### ADDENDUM No. 1

REQUEST FOR QUOTATIONS No.: 1220-040-2022-063

TITLE: Surrey RCMP HQ – Roof and Skylight Replacements

ADDENDUM ISSUE DATE: September 28, 2022

**1**  
**R4** SKYLIGHT CURB DETAIL  
 SCALE: 3"=1'-0"

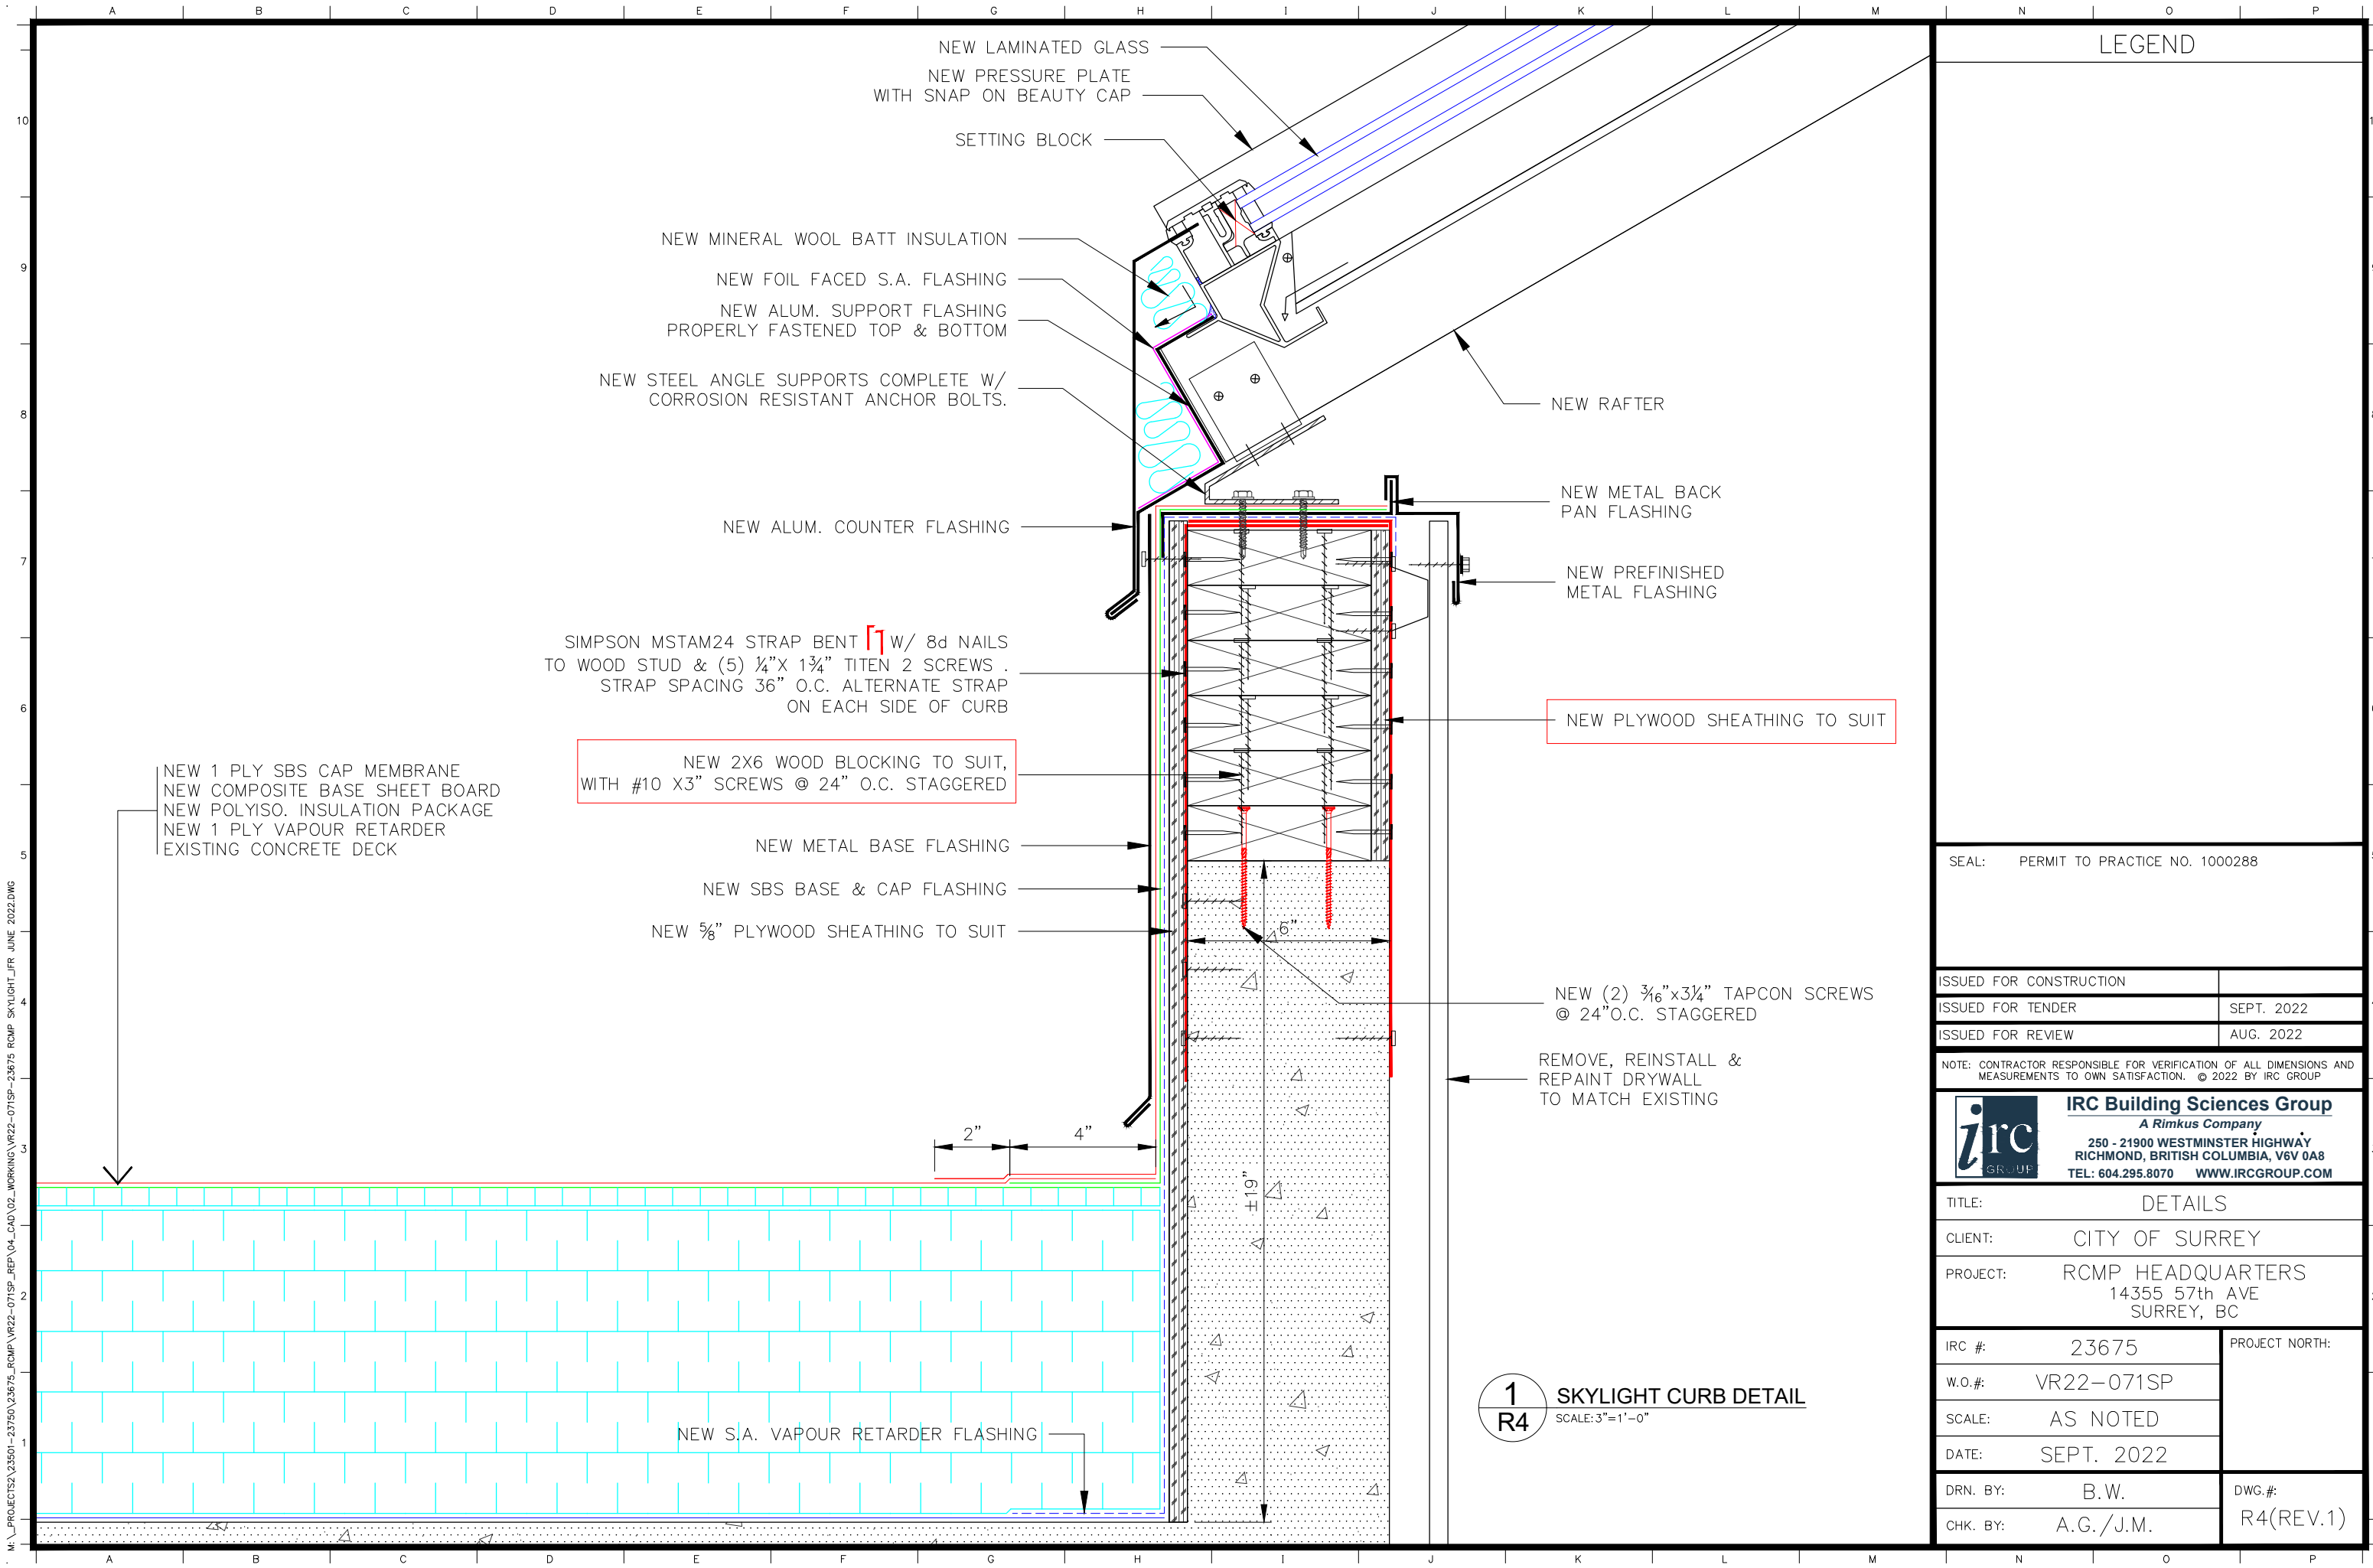
- 1. Contractor is to modify the parapet slope in order to slope towards the building at 4%. Remove the installation of a cap sheet membrane and the metal parapet cap from the scope of work at the areas surrounding the skylights only. Allow for installation of a new 8% plywood backslope cricket with shims, sloping away from the skylight, in order direct water**

around the skylight and onto the roof level. Hold back the wood cricket roughly 4 inches from the exterior parapet edge. Install a reinforced PMMA liquid membrane over the entire base sheet, and lap onto the surrounding cap sheet membrane around the skylight area, SBS sheet membrane is not required in this area. Install PMMA liquid membrane per the manufacturers written installation instructions. Install a continuous metal drip edge at the entire parapet, and hold back the metal cap roughly 100mm (4") from either side of the skylight edge to allow drainage around the skylights. Full metal cap is not required at the skylight, only a drip edge. Skylight wood curb height is to be adjusted to suit the revised finished roof level above the cricket. Refer to revised Drawings R1 (REV.1), R4 (REV.1), R5 (REV.1).
